RE: Luxelocker Conceptual Grading & Drainage Plan Engineer's Stamp Date: 06/03/22 Hydrology File: B18D031

PO Box 1293 Based upon the information provided in your submittal received 06/07/2022, the Conceptual Grading & Drainage Plan **is not** approved for action by the DRB on Site Plan for Building Permit. The following comments need to be addressed for approval of the above referenced project:

# SECTION A-A'

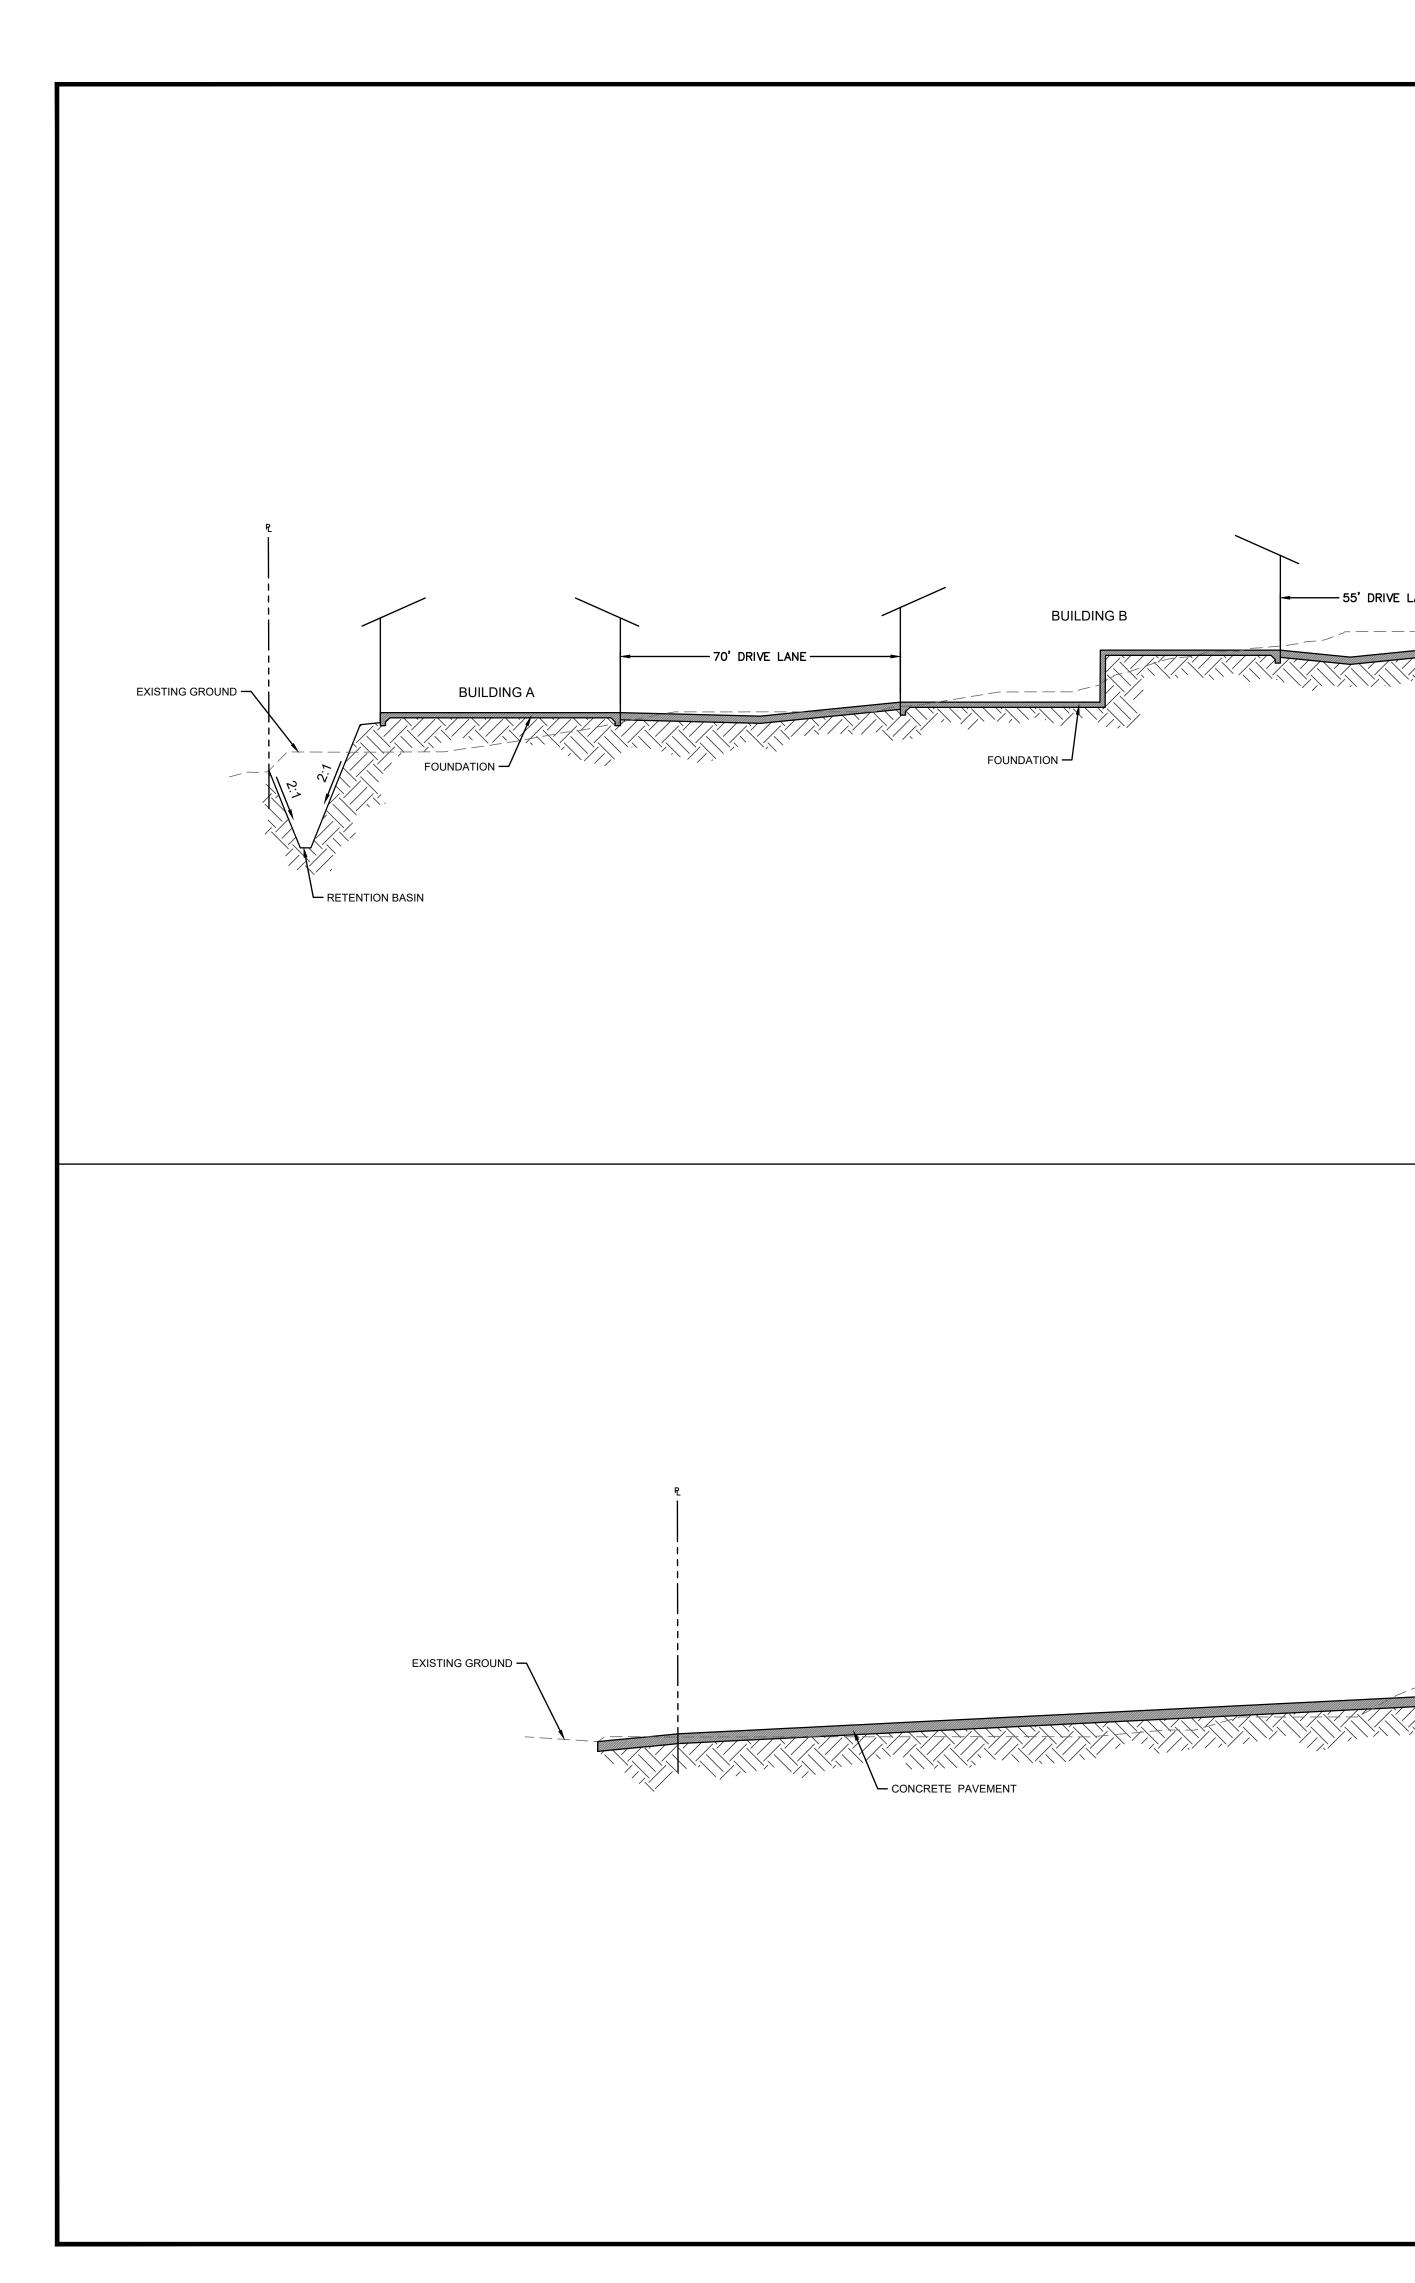
- Albuquerque 1. Hydrology does not to review the Utility Plan (water & sanitary sewer). This is done through Albuquerque Bernalillo County Water Unity Authority (ABCWUA).
- NM 87103
   2. Hydrology also does need the Site's Cut & Fill calculation and the overall site sections. Hydrology does need sections through the stormwater quality ponds and through any retaining / garden walls (only if you have them).
